June 27, 1997

RE: Petit Lake Dam Site  
Summary of Preliminary Engineering Evaluation

Exhibit A - Spillway Slab Repair Detail

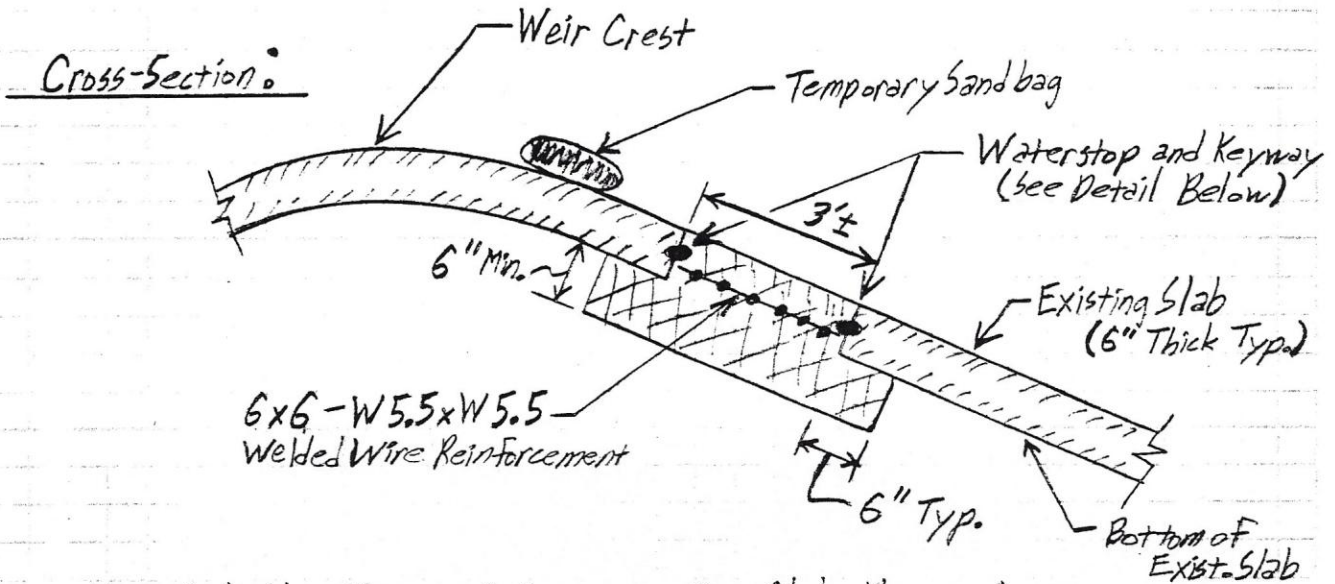
appears to be leaking under the principal control weir and then exiting through the spillway slab on the right side (looking downstream). Upon closer field inspection, this condition does not appear to be caused by water seepage flows beneath the spillway slab. Instead, there is a small steady discharge from the cold water release pipes onto the spillway and flowing over an irregularity in the concrete finish of the slab downstream. This irregular surface of the concrete slab is causing a small hydraulic jump as water flows over it, and this condition may have been misinterpreted by Safe Dams as leakage underneath the spillway. The irregularity should be fixed by using sand bags to temporarily deflect water flows away from the small depression, and then repair slab in accordance with enclosed Detail A to match the relatively smooth uniform finish of the adjacent concrete slab areas.

- Notes:
1. Use 5000 psi Concrete For Slab Repair Area.
  2. Sawcut Existing Slab to remove small depression and about 6" to either side (approx. 3'x3' area).
  3. Use sand bags to reroute water flows away from repair area and keep exposed subgrade in dry condition.

Exhibit B - Schematic Illustration of Water Surface Conditions

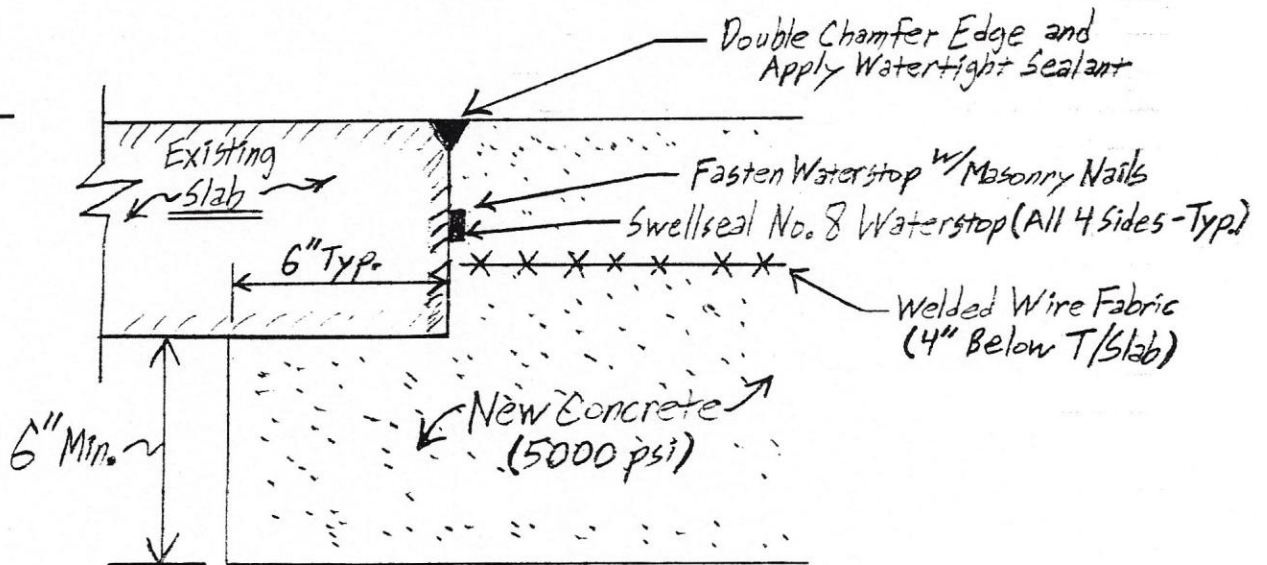
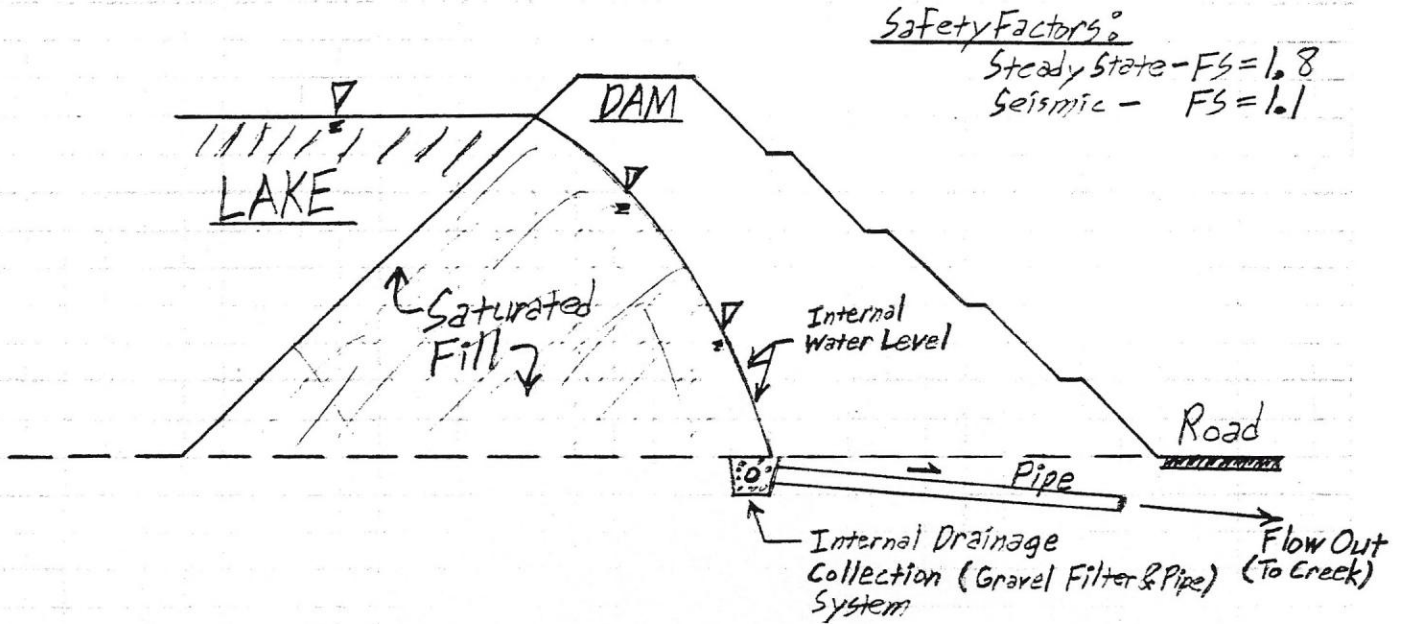
- 4) Our primary engineering concern for this project has now shifted from the apparent seepage phenomenon to a more serious concern about the impact of a relatively shallow water surface level (phreatic surface) through the dam relative to overall stability. Our review of the piezometer data provided verbally by Mr. Robertson and field measurements from these monitoring wells during our May 13<sup>th</sup> site visit have suggested that a shallow water surface has existed within 12 feet or less of the downstream slope face's lower sections since within 1-2 years after its construction. Based on our experience with similar earth fill dams, this water surface should be much deeper on a structure of this size, particularly with a designed clay core and internal drainage system. The primary effect of an elevated internal water surface within this dam would be a substantial decrease in stability safety factors. Based on our preliminary assessment of this condition, we conducted a limited computer analysis based on several assumptions to evaluate the potential impacts on overall stability of an embankment of this height and geometry.

The "as-designed" cross-section geometry was based on the original construction plans showing 6 berms connected by 2.5H:1V slopes, and the resulting minimum safety factors were 1.8 for steady state conditions and 1.1 for seismic event. These two safety factors exceed the Safe Dams' required minimum values of 1.5 and 1.1 respectively for these two design conditions.

Next, the "as-built" embankment geometry was evaluated using the surveyed cross-section from the Corps of Engineers Phase I inspection report (5 berms connected with 2H:1V slopes). This condition also incorporated an assumed phreatic surface interpolated from the piezometer readings and location where seepage has been observed at the surface (see exhibit B for schematic illustration of water level conditions). The resulting calculated minimum safety factors were 1.1 for steady state conditions and 0.7 for the seismic event. These values are well below the Safe Dams' design requirements, and raise some serious concerns about the potential stability of the existing dam structure.
